dsPIC33EPXXXGP50X, dsPIC33EPXXXMC20X/50X and PIC24EPXXXGP/MC20X Family Silicon Errata and Data Sheet Clarification

The dsPIC33EPXXXGP50X, dsPIC33EPXXXMC20X/50X and PIC24EPXXXGP/MC20X family devices that you have received conform functionally to the current Device Data Sheet (DS70657H), except for the anomalies described in this document.

FIGURE 1-1: TIMING DIAGRAMS FOR CENTER-ALIGNED AND EDGE-ALIGNED MODES

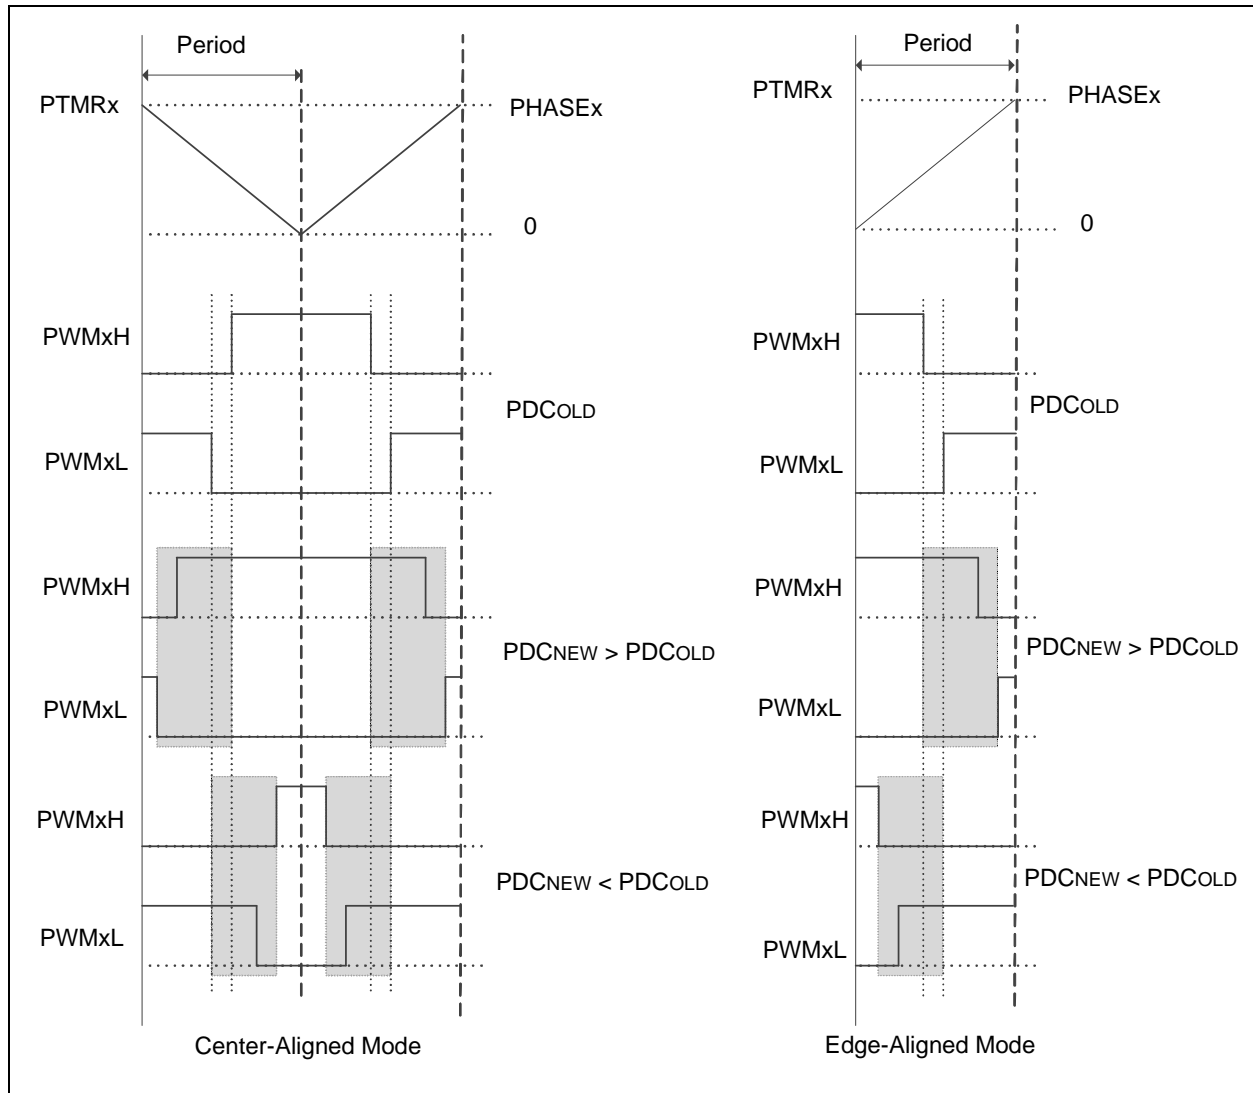
The PWMx generator may not assert dead time on the edges of transitions. This has been observed when all of the following conditions are present:

- The PWMx generator is configured to operate in Complementary mode with the independent time base or master time base;
- Immediate update is enabled; and
- The value in the PDCx register is updated in such a manner that the PWMxH and PWMxL outputs make an immediate transition.

The current duty cycle, PDCOLD, newly calculated duty cycle, PDCNEW and the point at which the write to the Duty Cycle register occurs within the

PWMx time base, will determine if the PWMxH and PWMxL outputs make an immediate transition. PWMxH and PWMxL outputs make an immediate transition if the Duty Cycle register is written with a new value, PDCNEW, at a point of time when the PWMx time base is counting a value that is in between PDCNEW and PDCOLD. Additionally, writing to the Duty Cycle register close to the instant of time where dead time is being applied may result in reduced dead time, effective on the PWMxH and PWMxL transition edges.

In [Figure 1-1](#), if the duty cycle write occurred in the shaded box, then PWMxH and PWMxL will make an immediate transition without dead time.

None.

However, in most applications the duty cycle update timing can be controlled using the TRIGx trigger or special event trigger such that the above mentioned conditions are avoided altogether.

FIGURE 1-2: TIMING DIAGRAM

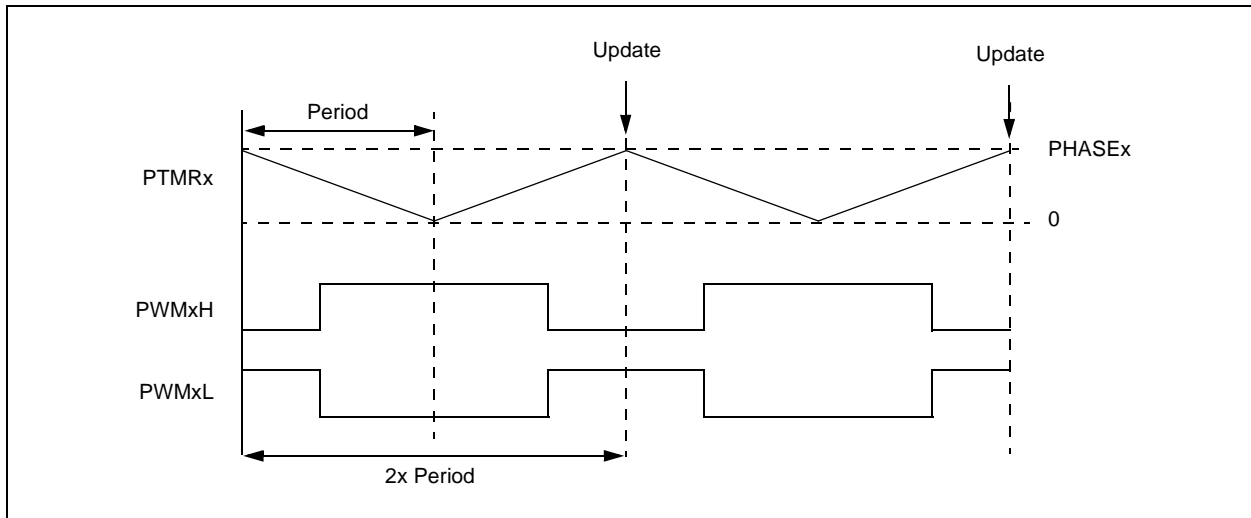
In Center-Aligned mode, updates to active MDC/PDCx/ALTDTRx/PHASEx registers occur only once every two PWM periods; that is, when the PWMx timer matches the PHASEx register. In other words, the double update feature is not available. Figure 1-2 illustrates this relationship.

None.

FIGURE 1-3: CORRECT AND INCORRECT POSITION COUNT CAPTURES

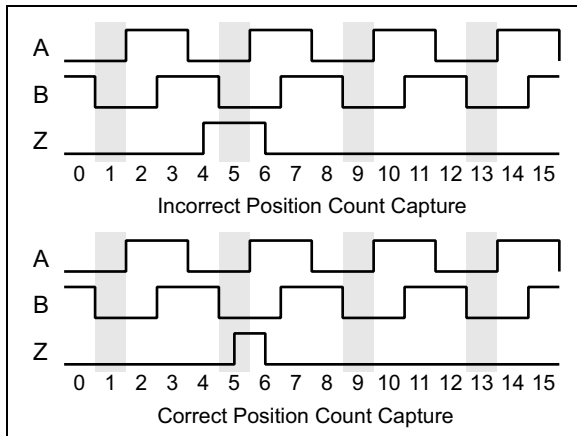
When index count position capture is being used (QCAPEN (QE11IOC<15> = 1), the position count may be one more or one less than the correct value, depending on the direction of the count.

This is only observed when the leading edge of the index pulse occurs prior to the leading edge of the index match state. When the index pulse starts after the leading edge of the index match state, the position count is captured correctly.

Figure 1-3 shows how this occurs. In these cases, Encoder Signals A, B and (index) Z are shown, with the module being configured for index match when A and B are '0'. The effects of a correct and incorrect capture are shown side by side (shaded area indicates the index match state); the position count is shown along the bottom.

There are two different work arounds depending on the encoder type.

For encoder signals with timing that ensures the index pulse always starts prior to the start of the index match state (i.e. encoders with a non-gated index pulse), measure the direction of the encoder motion. If the encoder is counting up, add one to the captured position count; if the encoder is counting down, subtract one from the captured position count.

For encoder signals where the index pulse leading edge approximately coincides with the start of the index match state (i.e. encoders with a gated index pulse), a small delay can be added to the index pulse, for instance, by using a simple R-C filter.

If the encoder does not meet either of these criteria, no work around is available.

FIGURE 1-4: TIMING DIAGRAM

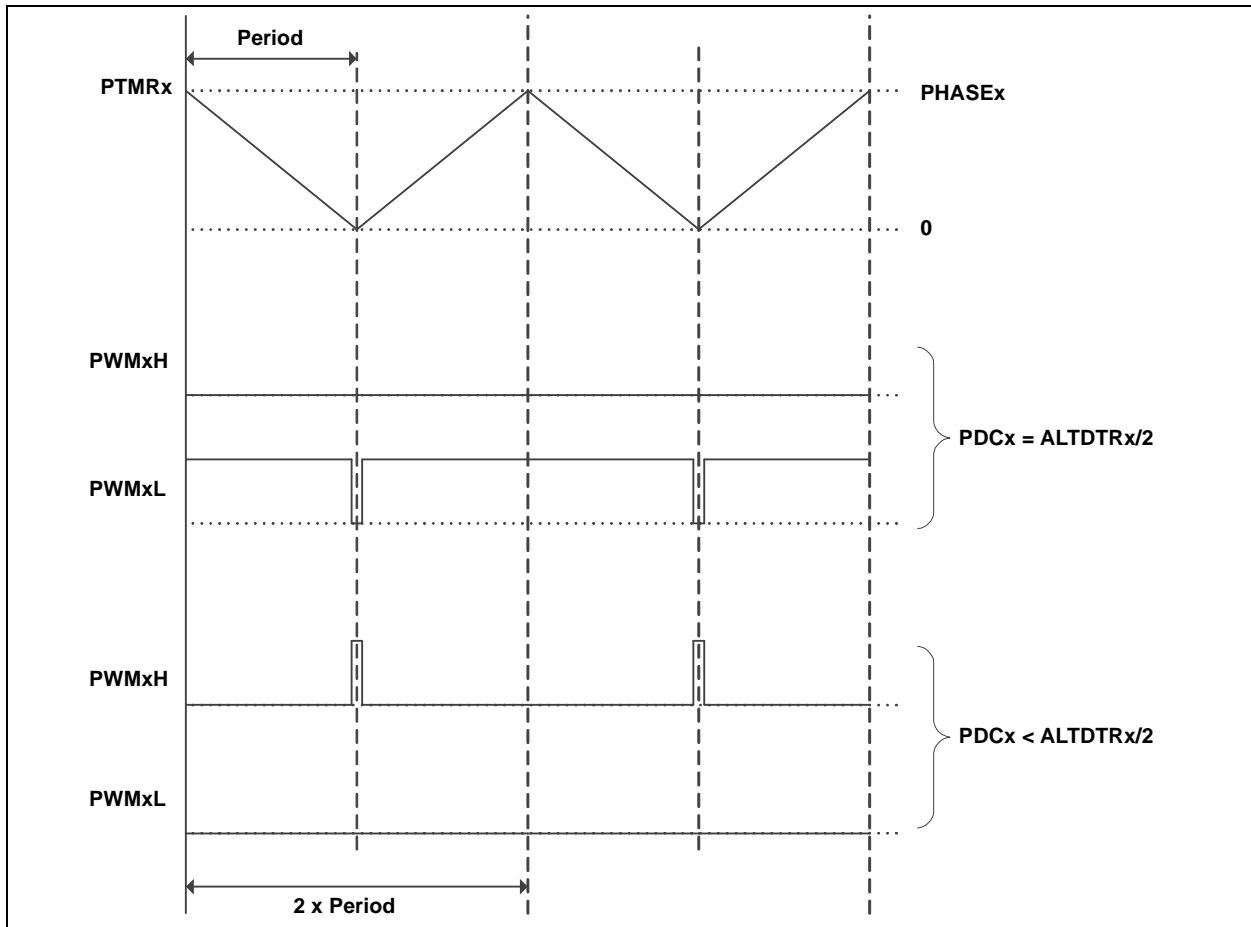
In Center-Aligned Complementary mode with Independent Time Base, if the value in the PDCx register is less than one-half the value in the ALTDTRx register, the PWMx generator will force the PWMxL to low and the PWMxH will generate pulses of width less than twice the dead time, as shown in Figure 1-4.

Include a software routine to ensure that the duty cycle value written to the PDCx register is always at least one-half of the value in ALTDTRx. Example 1-2 shows one method, with PDCtemp representing the variable which has the value to be written to the PDCx register. Alternatively, for duty cycle values less than half the desired dead time value, zero out the ALTDTRx register or dynamically reduce the value in the ALTDTRx register, such that ALTDTRx is always equal to 2 * PDCx, as shown in Example 1-3.
